Service Bulletin

Bulletin No. 2009-08

Drum Coupling Change

43525

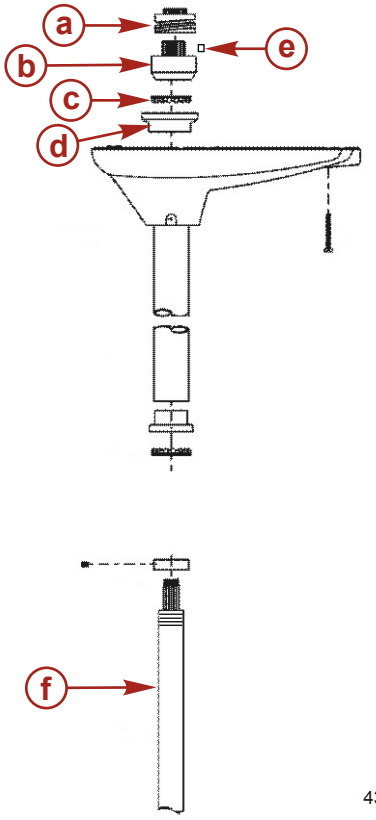
Drum coupling part number MFM06402T is no longer available. The old style drum coupling was secured to the column shaft with a rivet. The new style drum coupling is threaded onto the column shaft and secured with a set screw.

If drum coupling part number MFM06402T requires replacement, a new drum coupling with a set screw, roller bearing, bearing cup, drum control, and threaded column must be installed. Refer to the appropriate service manual for installation instructions.

a - Drum control
b - Drum coupling
c - Bearing
d - Bearing cup
e - Set screw
f - Threaded column
